Independent Expert Panel for Mining in the Catchment

Initial report on specific mining activities at the Metropolitan and Dendrobium coal mines

12 November 2018

Initial report from the Independent Expert Panel for Mining in the Catchment

Figure 24: Predicted closure profiles along the Eastern Tributary for the Preferred Mine Plan at the time of PAC assessment in 2009 (DoP, 2009)

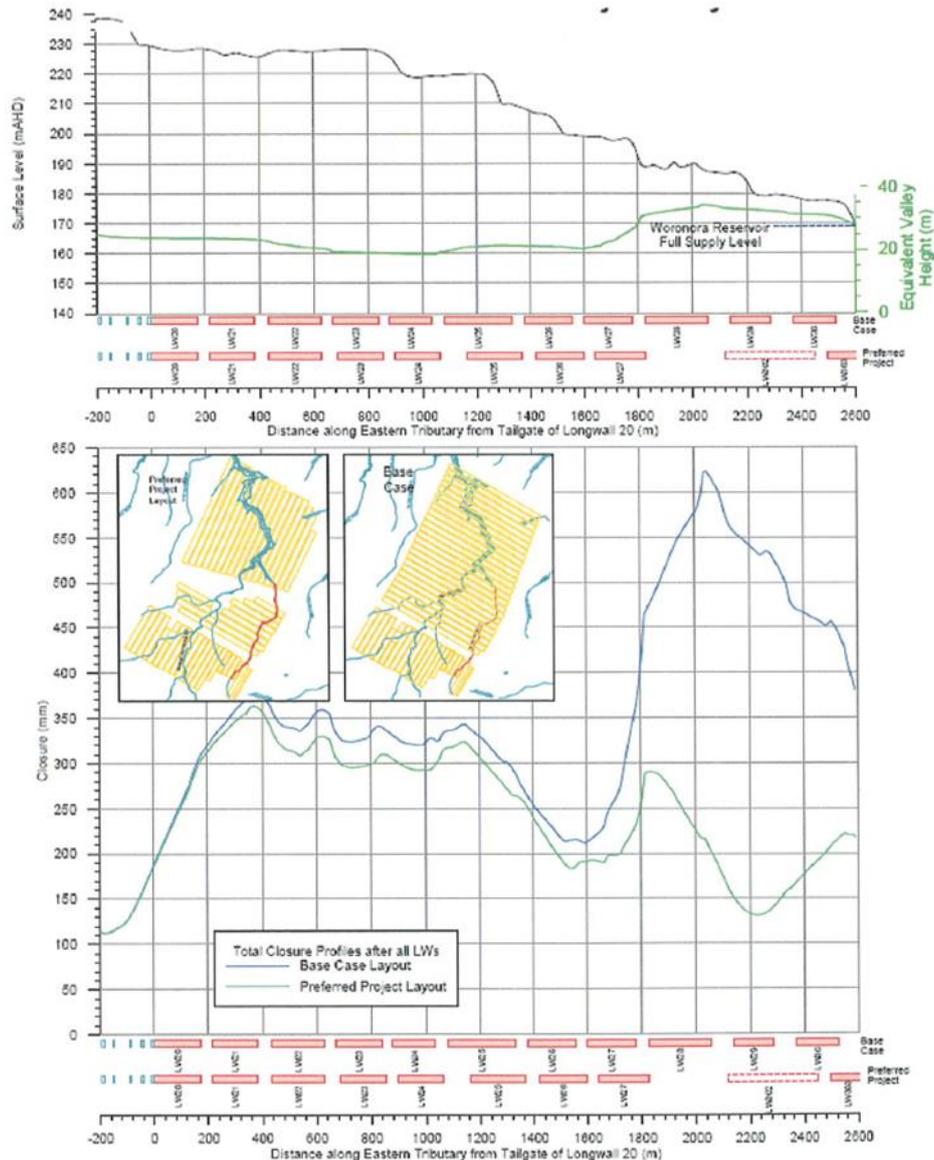
The Panel has had regard to the closure predictions shown in Figure 24 that were presented to the PAC and attached to the Conditions of Approval for the mine plan and to the performance measures set in the Conditions of Approval. Given the uncertainty associated with reliably predicting valley closure and its impacts, the Panel is of the view that the historic criteria of a maximum of 200 mm predicted closure for avoiding significant environmental consequences should be revised downwards, at least for watercourses.

Figure 33: The Tammetta and DGS databases shown as A) extraction height plotted against effective panel width and B) as depth of mining plotted against effective panel width, with the corresponding information also shown for Dendrobium Mine and Metropolitan Mine

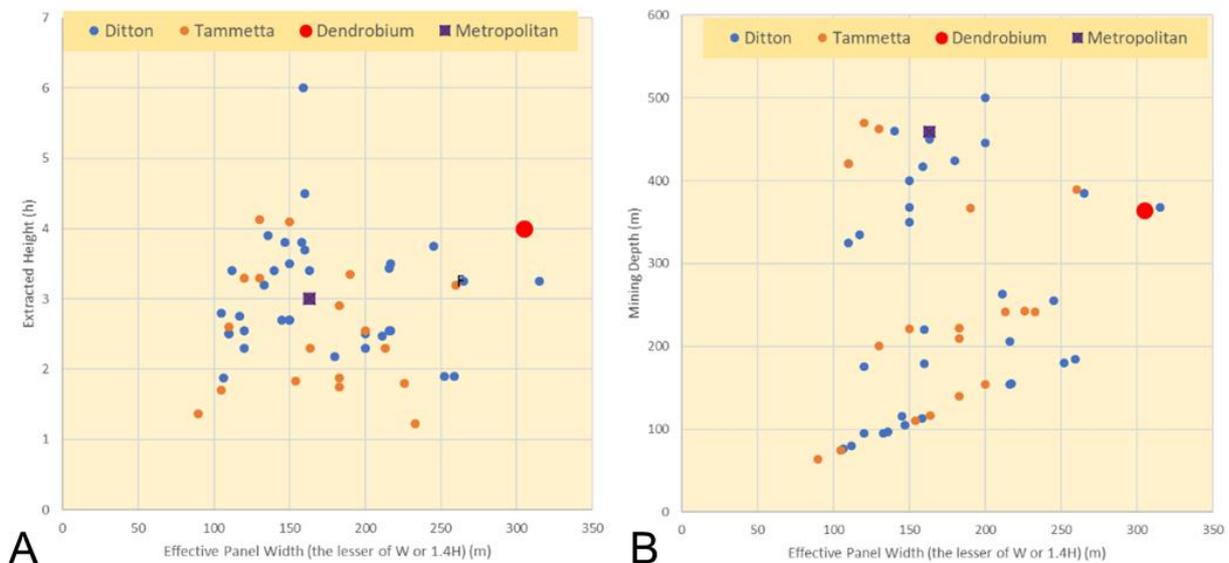
Figure 33 shows that the mining parameters associated with Metropolitan Mine are common to both databases (surrounding clusters). However, the parameters associated with Dendrobium Mine plot as an outlier with only one data point nearby which is Springvale Mine in the DGS database.⁵³ Significantly different subsidence outcomes are associated with these two data sets as illustrated in Figure 12.

This is not the complete picture as the equations are based on sets of data, with each set comprising three parameters. The Panel has assessed this factor and formed a view that conclusions drawn from presenting the data in Figure 33 as sets of two instead of three parameters are reasonable.

Figure 34: The 2013 Tammetta and 2014 DGS databases plotted in terms of A) effective panel width and B) height of complete drainage per metre of extraction height

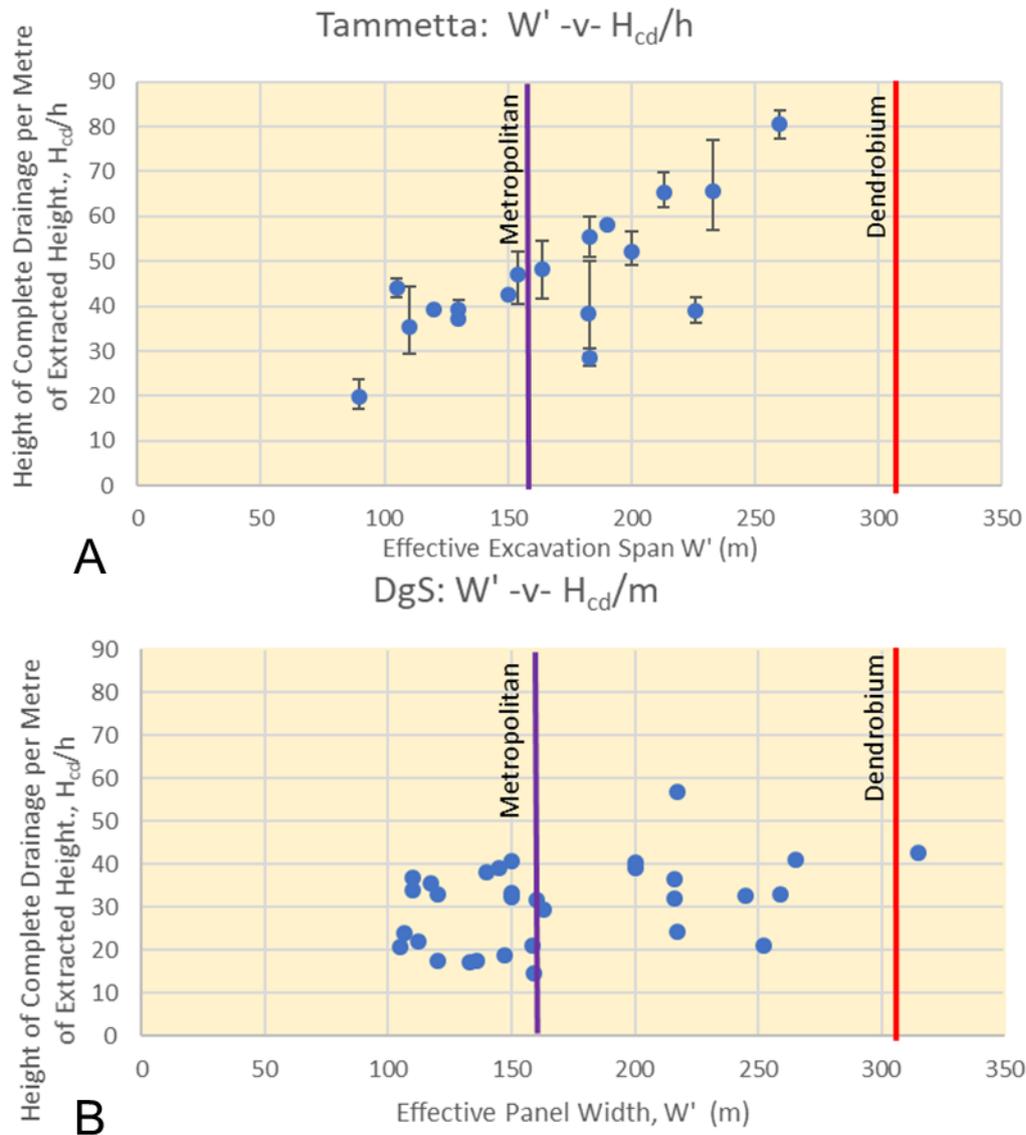
From a geotechnical perspective, the increase in normalised height of complete drainage with increasing panel span (Figure 34A) displayed by the Tammetta database is to be expected but it is remarkably uniform by geotechnical standards. Conversely, the range in the normalised height of complete drainage about a given panel span in the DGS database is to be expected but the relative insensitivity of this range to increasing excavation span is surprising (Figure 34B). Data scatter about a given panel width is an expected consequence of the uncertainty associated with estimating the height of complete drainage and the range of factors noted in Chapter 2 that influence rock mass response to mining.⁵⁵ However, except for one data point (where it is known that the A Zone interacted with the surface), the range in height of complete drainage in the DGS database changes very little as panel width is increased, with the maximum height of complete drainage relatively fixed at approximately 40 m per metre of extraction height.

Figure 37: Comparison based on the DGS database between predictions of height of complete drainage calculated with the DGS geometry equation (blue) and the DGS geology model with t' set to 1 m (orange).

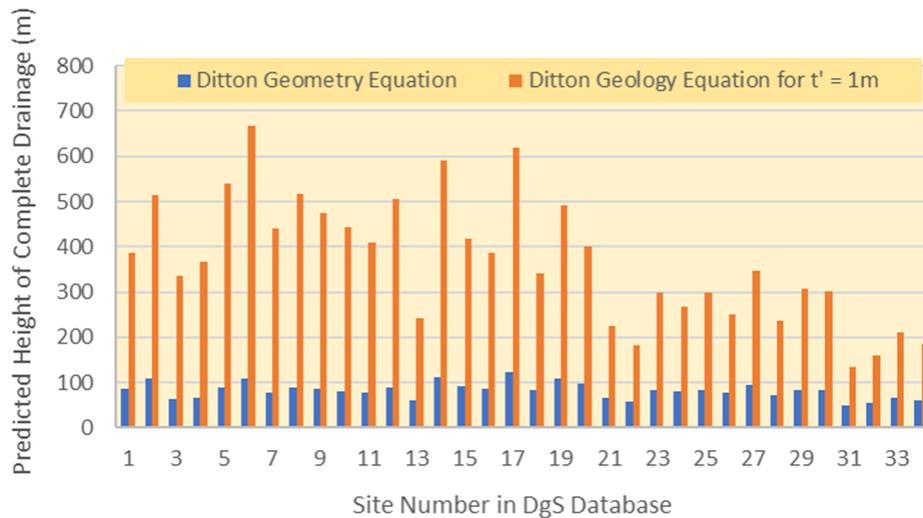
The Panel has investigated this aspect based on the logic that if mechanistically sound, the DGS geology equation and the DGS geometry equation should give similar predictions when no thick strata units are present since both equations were calibrated to the same database. Accordingly, working backwards, the predictions of the geometry model were compared to the predictions of the geology model with t' set to 1 m⁷⁰ for the DGS database to produce (as is to be expected), the significant differences in outcomes shown in Figure 37.

The application of an appropriate t' parameter in the geology model reduces this disparity so that the two equations predict similar outcomes. Therefore, the Panel next plotted the t' value assigned to each site in the DGS database against its panel width-to-depth ratio. The results, shown in Figure 38, reveal that except for one site, the selected t' values hover around 20 m for sites where the panel width-to-depth ratio is greater than 1. They vary from about 20 m to 35 m for sites in the range $\approx 0.6 \leq W/H \leq 1$, and from 30 m to more than 100 m for panels where $W/H \leq \approx 0.6$. The single exception is the only Dendrobium site in the database, where t' is significantly greater than all other sites with a width-to-height ratio $W/H \geq \approx 0.6$.⁷¹

Figure 38: Effective strata unit thickness, t' , in the DGS database (DGS, 2014) plotted against the panel width-to-depth ratio of each site in the database

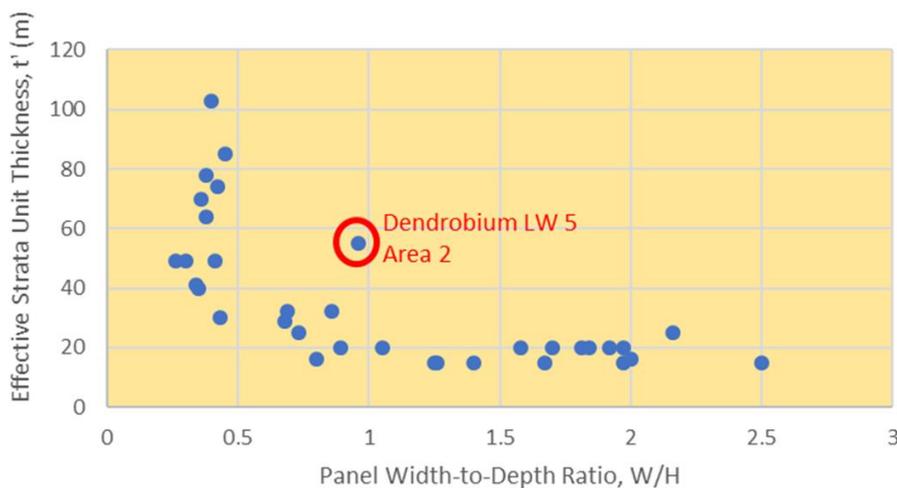
This suggests to the Panel that the ' t ' factor, effectively, acts as a calibration factor to compensate for the geology model not fully accounting for the delayed onset of caving and fracturing at lower range panel width-to-depth ratios, rather than representing a parameter that realistically reflects strata behaviour.

Figure 40: Metropolitan Mine model grid showing locations of the two introduced faults and their significant influence on groundwater systems (HydroSimulations, 2017a)

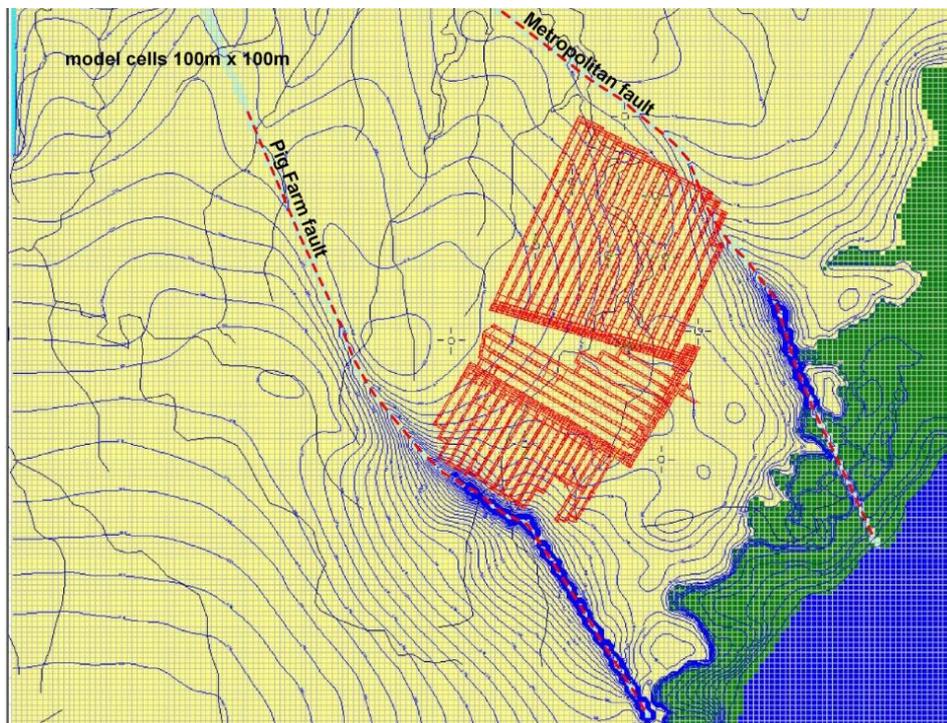
Most recently, two regional faults, the Metropolitan Fault and the Pig Farm fault, have been included. The two faults transgress large parts of the model and extend vertically from layer 7 to the deeper layer 17. They are represented by high vertical and horizontal conductivities assigned to specific cells.⁸⁰ The faults appear to be important elements of the flow model since the regional pressure head contours are clearly influenced by their presence as shown in Figure 40.
